Office Action Summary

10/574,103

DOMOLATO, MAURIZIO

The following office action is in response to the amendment filed on 01/22/2009. Claims 11-24 are pending in the application. Claims 11-24 are rejected as set forth below.

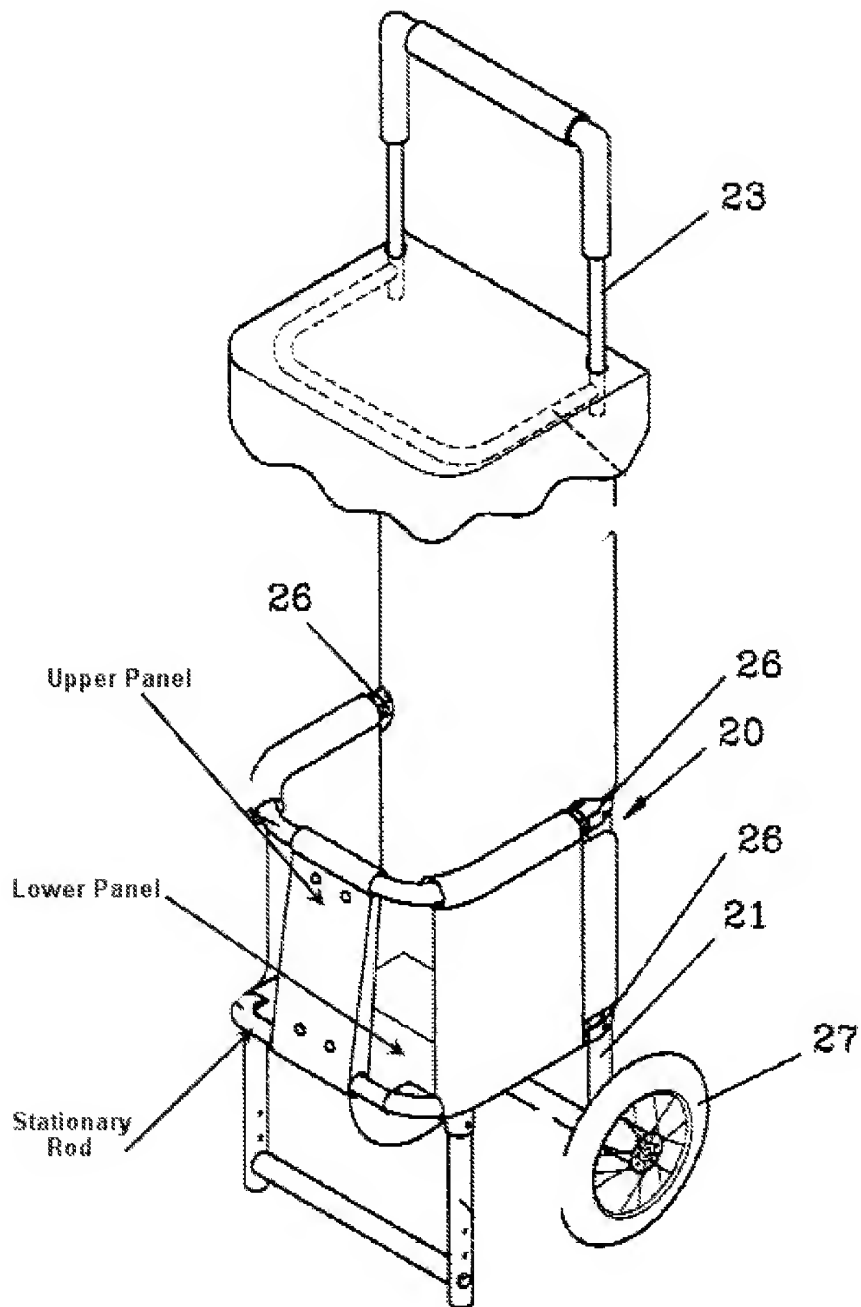
Claims 11, 15-18, 22, 23 and 24 are rejected under 35 U.S.C. 102(b) as being anticipated by Lin 6,000,713.

In re claims 11 and 23, with reference to Figures 3-5, Lin '713 disclose a vertical structure having both functions as a seat in a first positions and a partition in a second position comprising:

- A pair of upright supports (11) extending in the vertical position.
- A quadrilateral articulated frame composed of rods (13)(14).
- A lower pair of the rods (left and right sides of 14) hinged to the upright supports (11) at a lower part and an upper pair of the rods (left and rights sides of 13) hinged to the upright supports (11) at an upper part.

- An upper panel and lower panel attached to the frame, said frame adapted to allow the vertical structure to act as a seat with the lower and upper rods (13)(14) of the frame oriented perpendicular to the upright supports (Figure 5) and as a partition screen with the rods and the upright supports coinciding and the upper panel and the lower panel being coplanar. (dashed lines in Figure 4)
- Connecting parts (12) moving the frame, upper panel and lower panel between a first position with the lower panel providing a seat and the lower rods (13) perpendicular to the upright supports (11) and a second position with the upper panel and lower panel positioned vertically with the upper and lower pairs of rods (13)(14) coinciding and the vertical plane defined by the upper panel and lower panel being coplanar. (Figure 4)

- Wherein the frame has end stops (12) mounted to the rods (13)(14) which abut against the upright supports (11) when the seat position is reached.
- Wherein the rods are hinged to the vertical structure by pins (121) and the upright supports (11) remain vertical and non-displaced during operation while the frame is displaced between a first configuration acting as the seat and a second configuration acting as the partition screen.

- The lower rods (left and right sides of 13) are hinged with a stationary rod connected transverse to the upright supports (11). (shown above)
- Wherein the panel is a single piece secured between the rods and the stationary rod.

- Wherein the panel may be made of materials adapted to withstand the weight of a person. (inherently so, since the device serves as a chair)
- Wherein when the vertical structure is configured as a seat (first position) the upper panel is vertical to the lower panel and the upper panel is facing and completely spaced apart from the upright supports (11) by an upper pair of the rods (14) and a lower pair of the rods (13) extending away from the upright supports (11).
